# Service Bulletin

KNOCKING / SQUEAKING NOISE FROM FRONT STRUT BEARING

02-005/13

11/11/2013

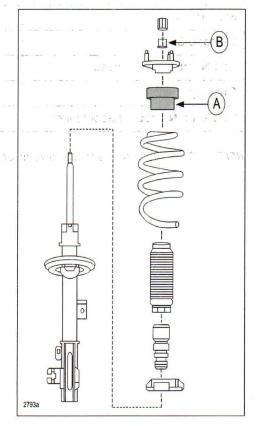
Some vehicles may exhibit a knocking / squeaking noise from the front strut bearing (A) due to front strut bearing damage when driving on rough roads and/or when turning the steering wheel while the vehicle is stopped.

The noise may be due to the upper housing of the front strut bearing being damaged when applying excessive force to the bearing during customer use. To eliminate the noise, the material and production method of the front strut bearing has been changed.

**NOTE:** The piston rod nut (B) requires replacement when the front strut bearing is replaced.

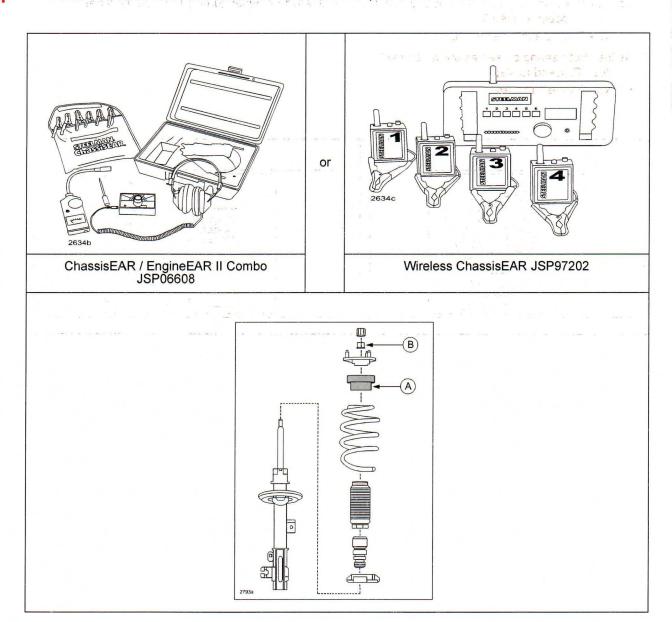
4. Use Special Service Tool (SST) ChassisEAR / EngineEAR II Combo JSP06608 or Wireless ChassisEAR > JSP97202 to confirm noise is coming from the upper part of front shock absorber (A) (shown below):

- 5. Using ChassisEAR SST, is the noise is coming from the upper part of front shock absorber?
  - · Yes Proceed to step 6.
  - No This bulletin does not apply.
- 6. Replace the front strut bearing with a new one according to MS3 online instructions or the Workshop Manual (section 02-13 FRONT SHOCK ABSORBER AND COIL SPRING DISASSEMBLY/ASSEMBLY).
- 7. Verify repair.
